Grid Code Alternative Form

GC0151 Alternative Request WAGCM2:

Grid Code Compliance with Fault Ride Through Requirements

Proposer: Alastair Frew, Drax

Figure 6 showing an interpretation of the existing legal text requiring the current to either be in the green box or on the red line

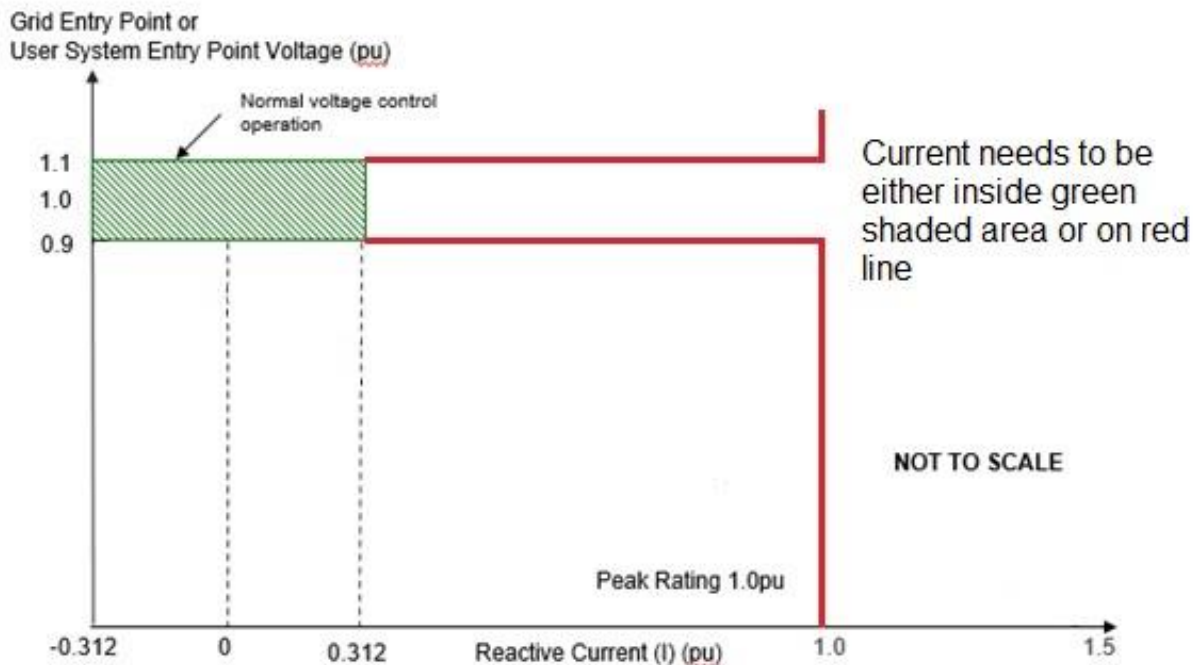
The area of the current legal text which technically creates the biggest problem in relation to compliance are in sections CC.6.3.15 (a)(ii) and ECC.6.3.15.9.2.1(a)(i) which currently state “for which the voltage at the Grid Entry Point (or Interface Point in the case of OTSDUW Plant and Apparatus) is outside the limits specified in CC.6.1.4, each Generating Unit or Power Park Module or OTSDUW Plant and Apparatus shall generate maximum reactive current “. If this requirement is drawn out on the figure 6 below where the current and voltage must always either be within the green shaded area or on the red line.

The reason this creates compliance issues is as drafted very few plants (if any) actually do this and it has presumably drifted in as a drafting oversight relating to PPM requirements. This issue has previously been identified in the workgroup GC0111 on Fast Fault Current injection and in the GC0137 VSM workgroup and has been fixed for new PPMs, however currently all synchronous generator and older PPM will technically be non-compliant with this FRT requirement as drafted. This issue was dealt with in GC0111 by adding a new Figure ECC.6.3.16(a), however this is more onerous than is required for GB Users so the graph shown in figure 7 is proposed with text changes as follows:-

Figure 8 showing a typical active power response of a unit at low load to a fault

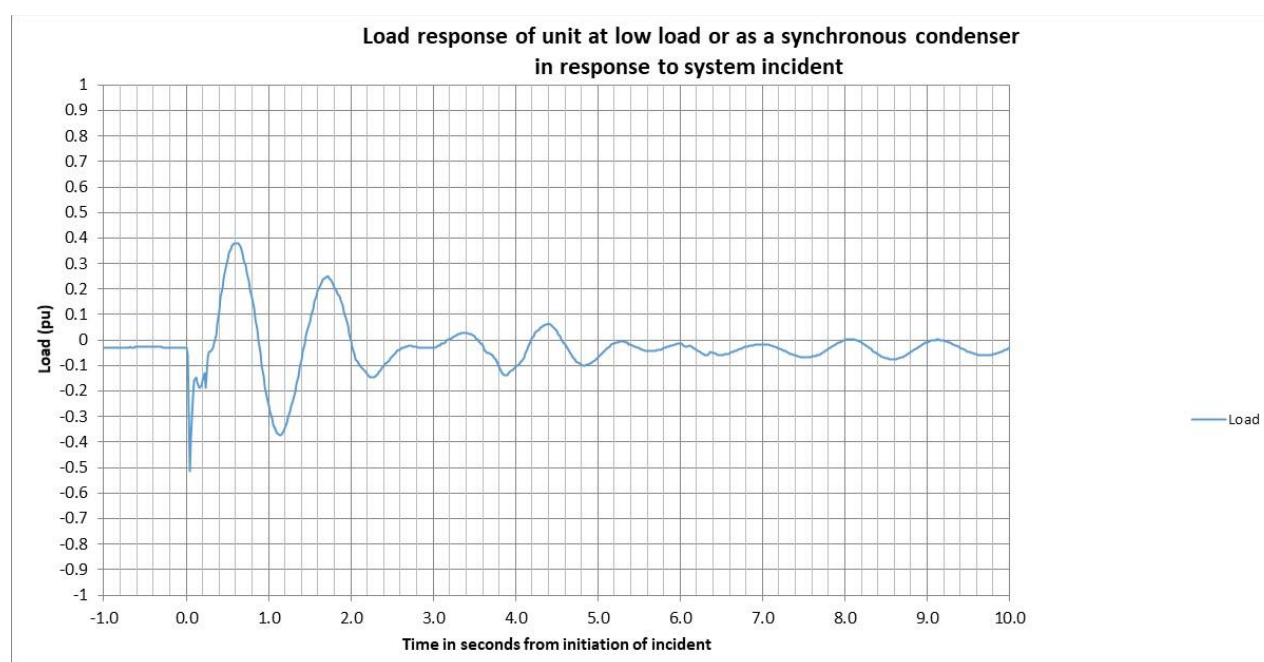
Whilst this works in principle at higher loads it does create an issue at lower loads if you consider at a real event for a unit operating as a synchronous condenser in figure 8.

If you look at the initial load which is 0.02 pu then 90% of this small number you get a very small number, it is also difficult to see how a sensible compliance assessment can be carried out at these levels and it is hence suggested that the tolerance should be changed to 10% of rated capacity around the pre-fault **Active Power** level as follows

“Active Power transfer capability, shall be restored to the level available immediately before the fault within plus or minus 10% of the **Rated Capacity**”
